STATE OF NEBRASKA
DEPARTMENT OF ROADS
ADDENDUM NO. 1
AND
ELECTRONIC BIDDING SYSTEM
AMENDMENT NO. 1
PROJECT NO. EACNH-STPC/E-6-7(114)
CONTROL NO. 20581
CALL ORDER F03
198TH – SKYLINE DRIVE, OMAHA
LETTING DATE: AUGUST 1, 2002

CO:DB:F03AD108

SECTION A-A

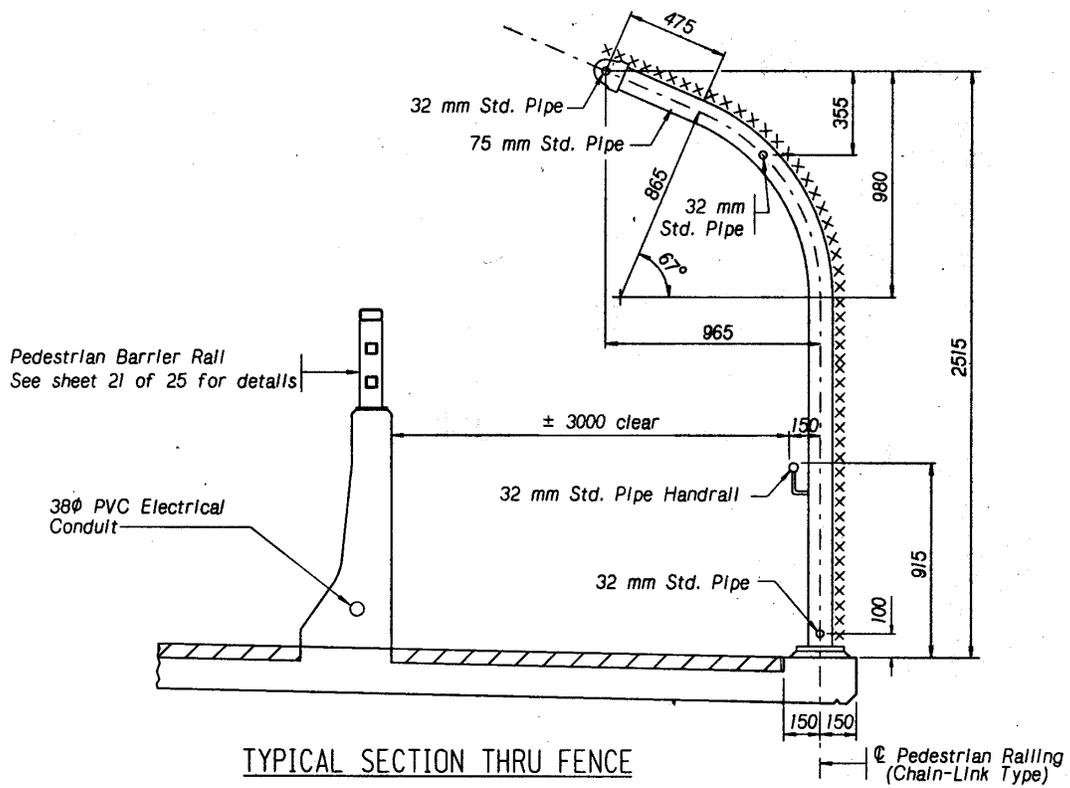
1. The “Section A – A” detail is void and superseded by the new “Section A – A” detail shown on the attached sheet.
2. The “Typical Section Thru Fence” detail is void and superseded by the new “Typical Section Thru Fence” detail shown on the attached sheet.

COMBINATION PILE/SHEET PILE WALL
 SEGEMENTS 2 THROUGH 6

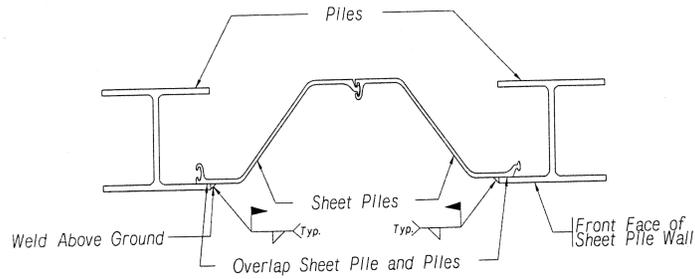
1. The sheet pile wall detail titled "AZ13 (50 ksi), SHEET PILE WALL, SEGMENTS 1 AND 7" void and superseded by the detail titled "SHEET PILE WALL, SEGMENTS 1 AND 7" as shown on the attached sheet.
2. The detail titled "HZ 775 D-14/AZ13 (60 ksi), COMBINATION H/Z SHEET PILE WALL, SEGMENTS 2 THROUGH 6" is void and superseded by the detail titled "COMBINATION PILE/SHEET PILE WALL, SEGMENTS 2 THROUGH 6" as shown on the attached sheet.
3. The DESIGN REQUIREMENTS table is void and superseded by the DESIGN REQUIREMENTS table shown on the attached sheet.

NOTE:
 Contractor may use either a 50 ksi or a 60 ksi design option for the segment detail shown. The design should be uniform within the different segment detail.
